PROJECTILE, 76MM/62 CALIBER, MK -- FROM AISI 9260 STEEL

Naval Weapons Laboratory  
Dahlgren, Virginia

FINAL REPORT

Contract N00178-74-C-0030

MANUFACTURING'S FLOW DIAGRAM

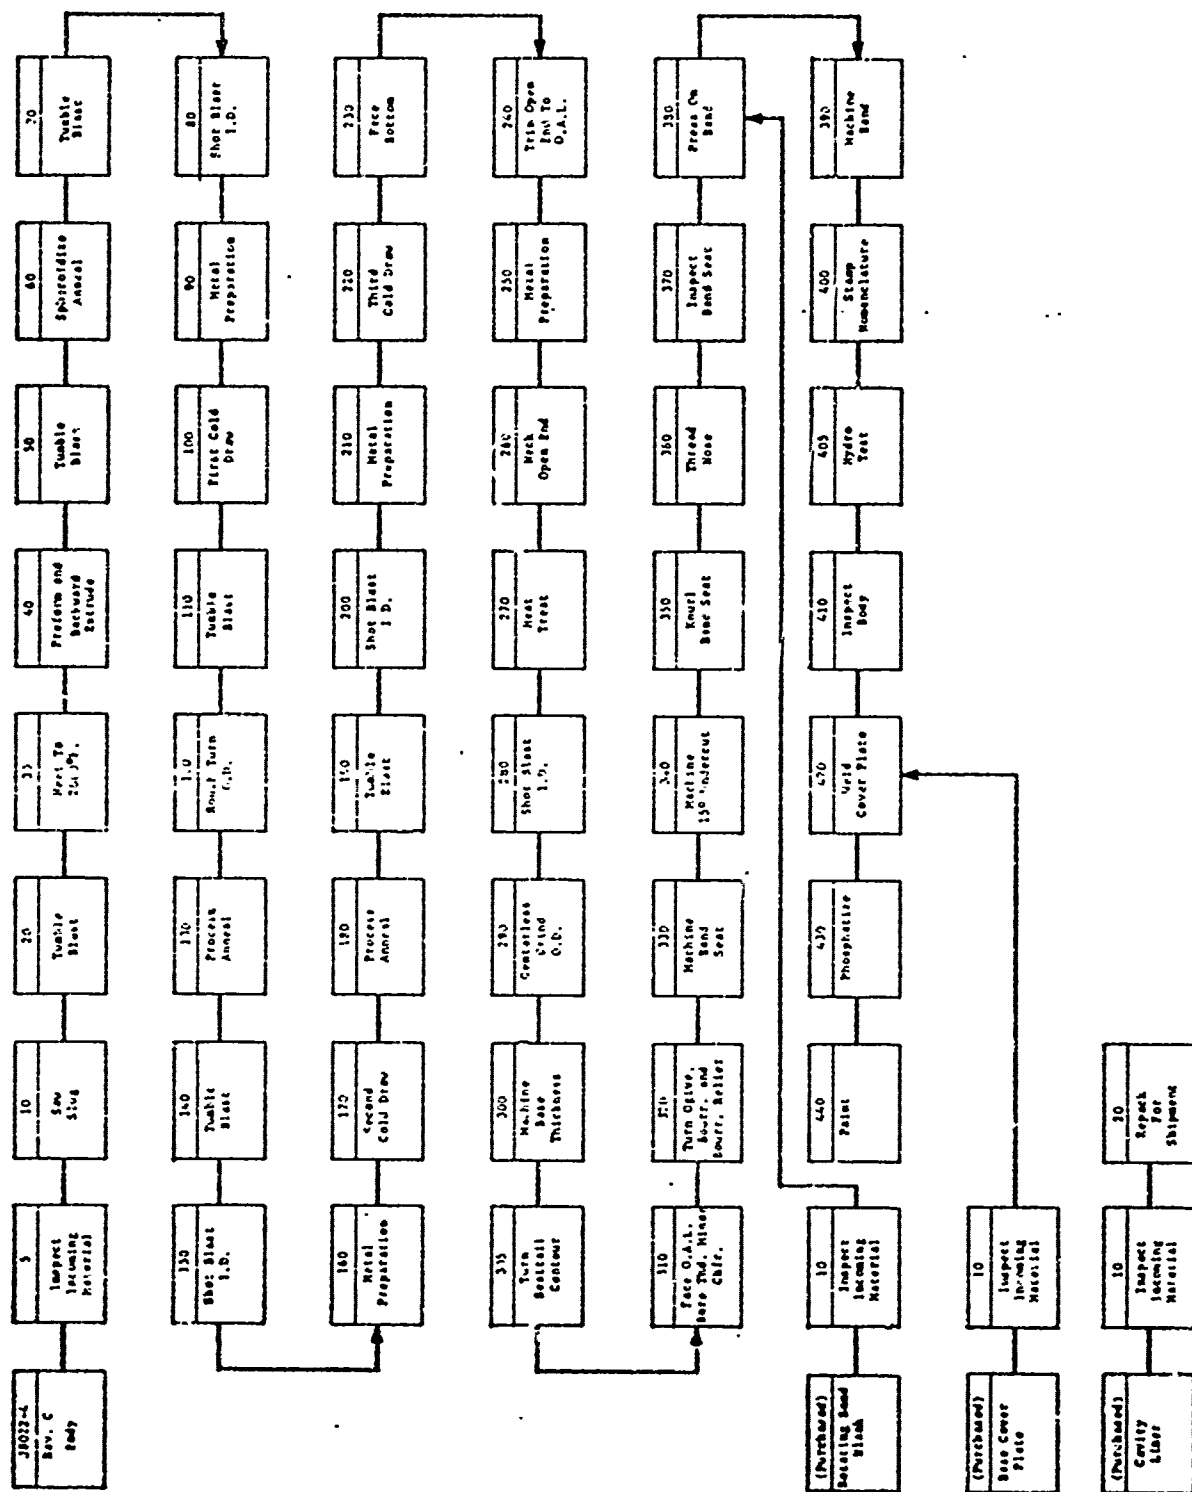
1.3.1 Chamberlain-generated metal parts drawings for release to the shops appear on Pages 5 through 7. A process schematic is presented on Page 8. Per terms of the contract projectile bodies were inspected ultrasonically at destination. The final 3,800 bodies were inspected employing Government-furnished gages.
